## Access Compliance Report Public Rights-of-Way (Curb Ramps)

Intersection ID: 49004Main Street:LITTLE\_GEM\_LNCross Street:STEELECROFT\_PYLocation:NEADA ID: 9257312BBFC8Ramp Type:PerpDiagInitial Pass/Fail:FailOverall Compliance:NoSeverity Score:22.5

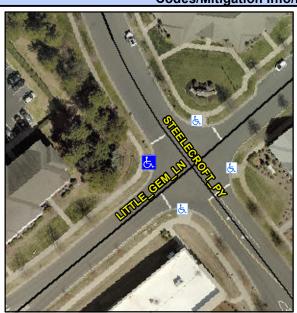
Not Found, R304.5.1, R304.2.2, R304.5.3

Field Measurements/Component Compilance					
Compliance Description		Data	Compliance Description		Data
N/A	Ramp Length (in)	96.0	No	Ramp Slope (%)	8.7
No	Ramp Width (in)	46.0	No	Ramp XSlope (%)	2.2
N/A	Flare Type LT	N/A	N/A	Flare Type RT	N/A
N/A	Flare Slope LT (%)	N/A	N/A	Flare Slope RT (%)	N/A
N/A	Flare Traversable LT?	N/A	N/A	Flare Traversable RT?	N/A
N/A	Landing Length (in)	N/A	N/A	DWS Provided?	N/A
N/A	Landing Width (in)	N/A	N/A	DWS Contrast?	N/A
N/A	Landing Slope (%)	N/A	N/A	DWS Length (in)	N/A
N/A	Landing X Slope (%)	N/A	N/A	DWS Full Width?	N/A
N/A	Landing Curb? (Y/N)	N/A	N/A	DWS Offset (in)	N/A
N/A	Shared Landing?	N/A			
N/A	Gutter Ponding?	N/A	N/A	Gutter Slope (%)	N/A
N/A	Gutter Lip Ht (in)	N/A	N/A	Gutter X Slope (%)	N/A
N/A	Painted X Walk1?	No	N/A	Painted X Walk2?	No
	X Walk 1 Direction	To SW		X Walk 2 Direction	To NW
N/A	X Walk 1 Width (in)	N/A	N/A	X Walk 2 Width (in)	N/A
	X Walk 1 Slope (%)	1.3		X Walk 2 Slope (%)	2.0

Remove & Replace Curb Ramp With Two New Directional Ramps or Equivalent.
